**PROJECT
FIELD REPORT**

PROJECT Aiken High School – Phase 2
PROJECT NO 2201-147220
CONTRACTOR H.G. Reynolds Construction
FIELD REPORT NO 14
DATE November 17, 2016
TIME 10:00am
WEATHER Sunny
TEMP RANGE Mid 70's
PRESENT AT SITE Matt Varner – LS3P; Mike Doyle – H.G. Reynolds
DISTRIBUTION Attendees; Dr. Shawn Foster, Kevin Chipman, Robbie Roberson and Beth Clark – ACPS; Jeffrey Reynolds and Ryan Reynolds – H.G. Reynolds; Allen Taylor, Brandy Bayne and Clint Riddle – LS3P Associates; Larry King – Johnson & King; Brian Melson, Chris Morse, Dan Reider, Mahyar Angooraj, Mark Watts– Buford Goff & Associates (BGA); Tilden Hilderbrand - Haas & Hilderbrand; Chris Waites – WM Building Envelope Consultants; Glenn Harshman – Camacho Associates
REPORT BY Matt Varner, LS3P

Brick at loading dock elevation and foam spray in progress area B

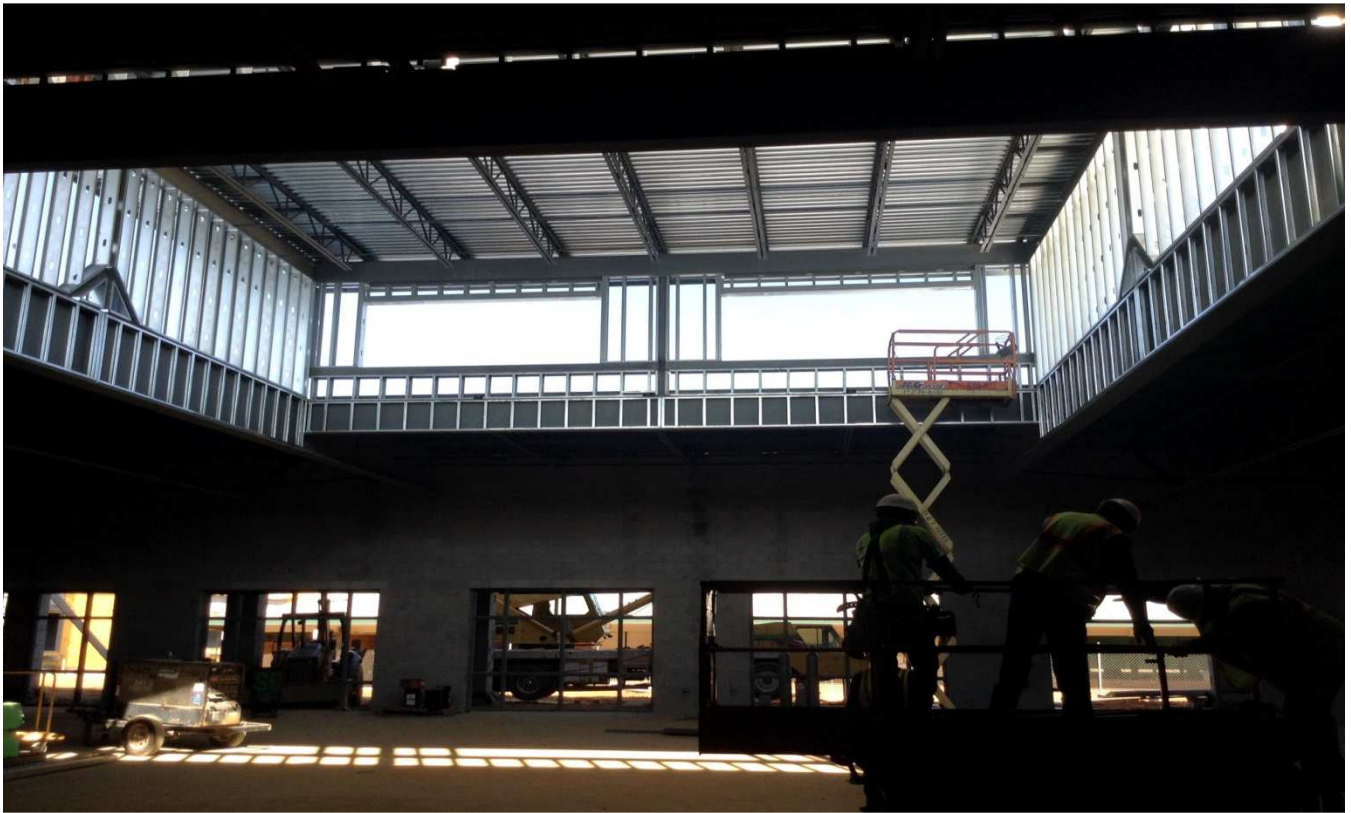
- 14-01 Owner to confirm if Chiller yard needs to be paved. Currently rock will be provided by contractor.
- 14-02 BGA will give direction on revised filter rack per owner request
- 14-03 Contractor will provide deduct for media center desks which will now be provided with furniture package.
- 14-04 Roofing inspection to identify locations where membrane curling and scuppers too low. Contractor is proceeding to fix problems.
- 14-05 Contractor was advised that flashed brick distribution is not acceptable at loading dock elevation and back of Building E. The contractor stated that better quality control measures are in place to prevent this from occurring elsewhere. It is anticipated that majority of bad brick will be covered by canopies and half walls at loading dock.
